REQUEST FOR INFORMATION	DATE: February 07, 2017	NO.: RFI-439
--------------------------------	--------------------------------	---------------------

Project Name: 15051-Webster University Interdisciplinary Science Building	Project No.: 15051
---	--------------------

Subject: Type EB Guardrail lighting.

E0201.B

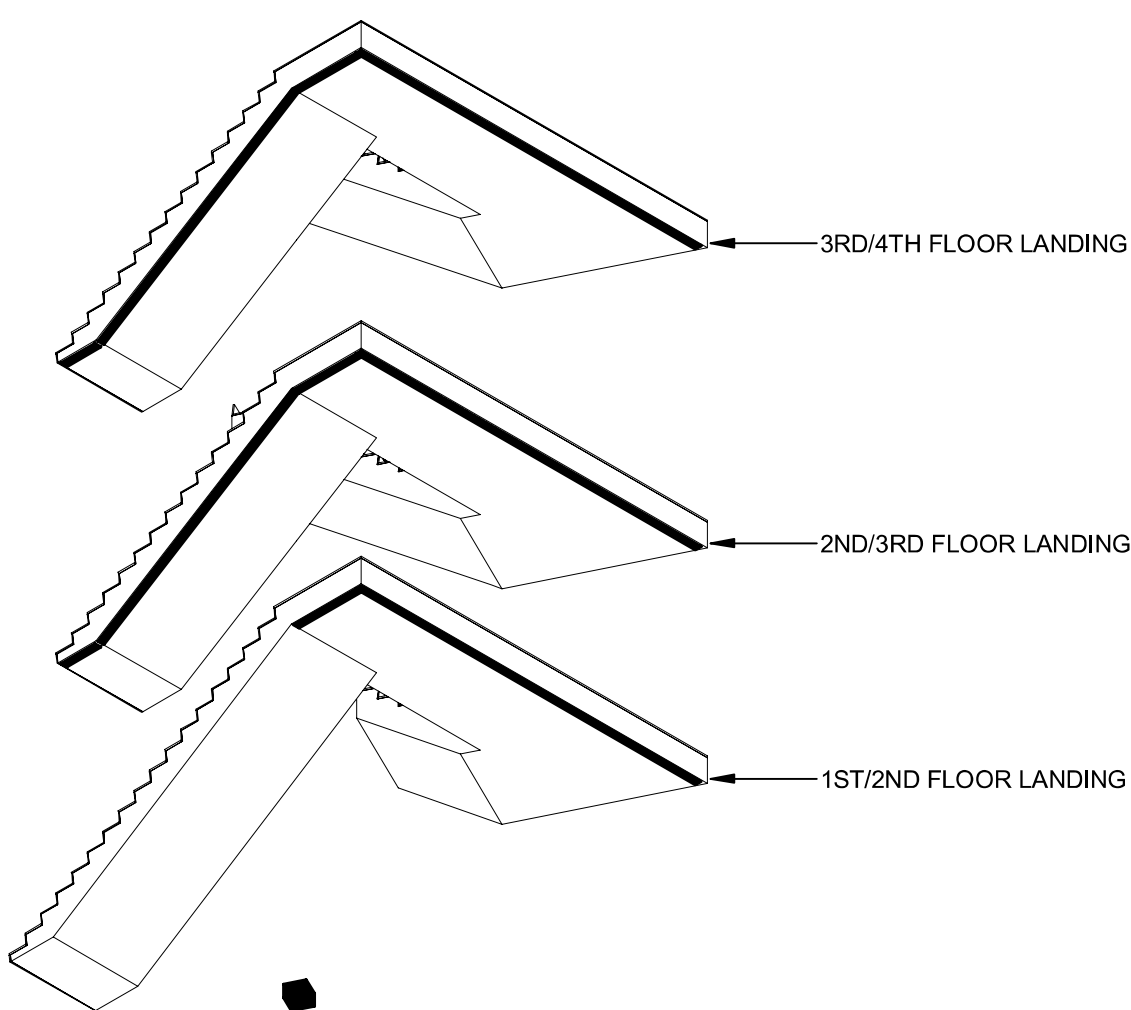
See attached J-box locations in the 1st floor ceiling that will be installed for the splice locations to change over from lighting supplied cable to the cabling to the remote drivers. The splice locations have been minimized as much as possible to feed guardrail lighting in both directions from each point. Please confirm this is acceptable.

J BOX LOCATIONS FOR GAURD RAIL POWER

This is acceptable. Provide white cover plate to match ceiling.
